**PICTURE #5
04/28/2011**

Per WKTV website, rainfall was 0.89".
This is the same source used by Mr. Schrantz in his report.

PICTURE #6
04/28/2011

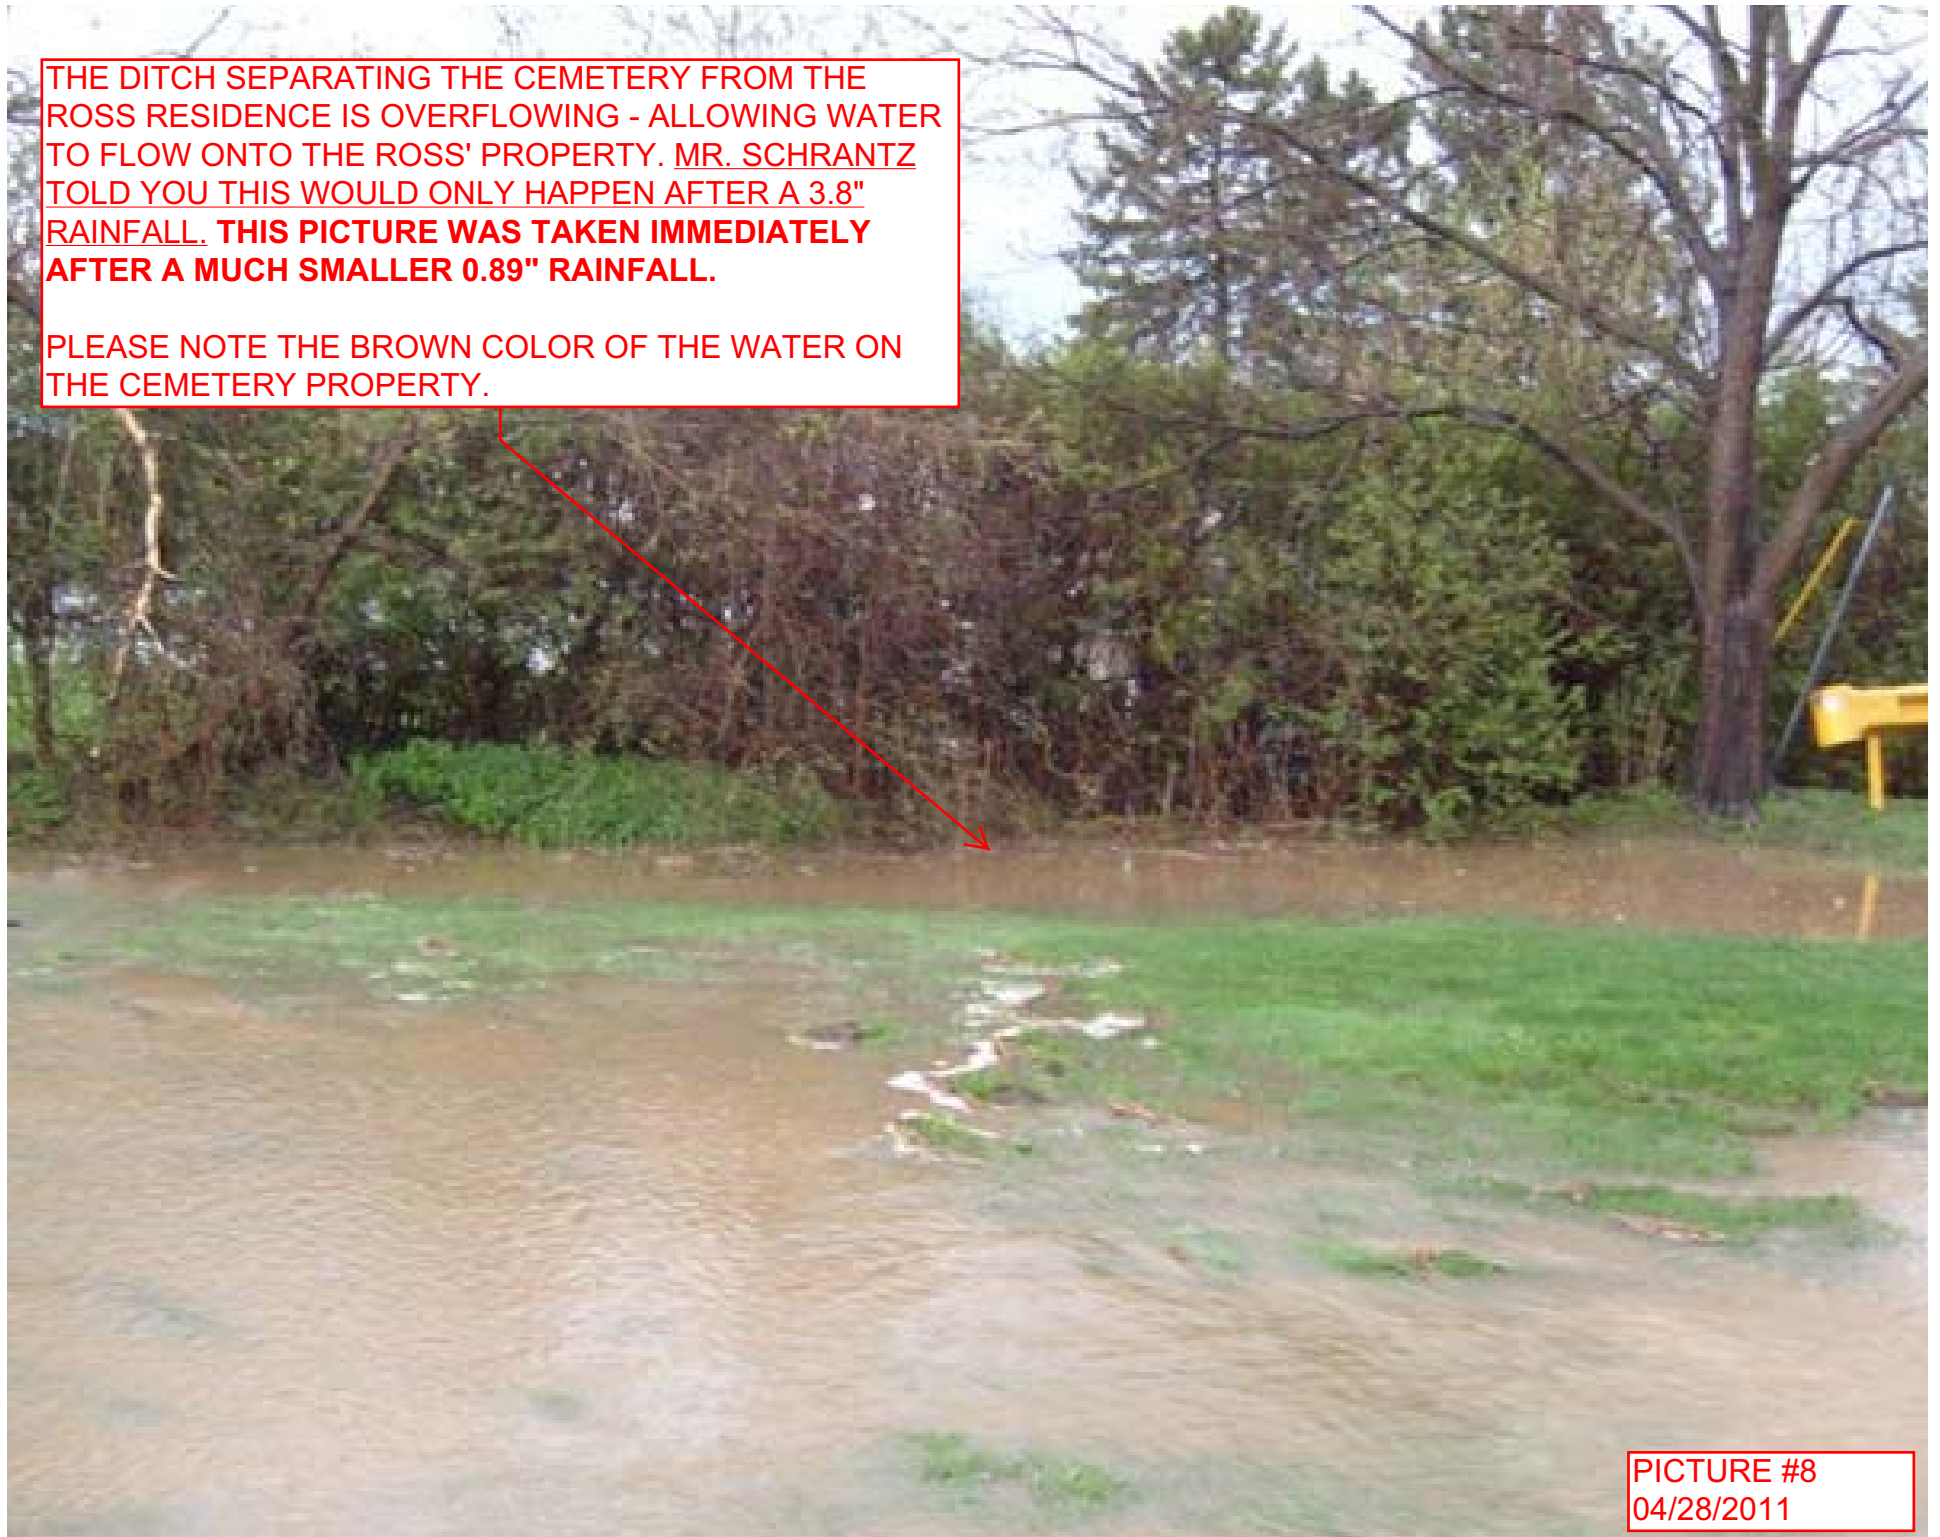
PLEASE TAKE NOTE OF THE
BROWN COLORED WATER BEING
DISCHARGED FROM THE
DETENTION POND.
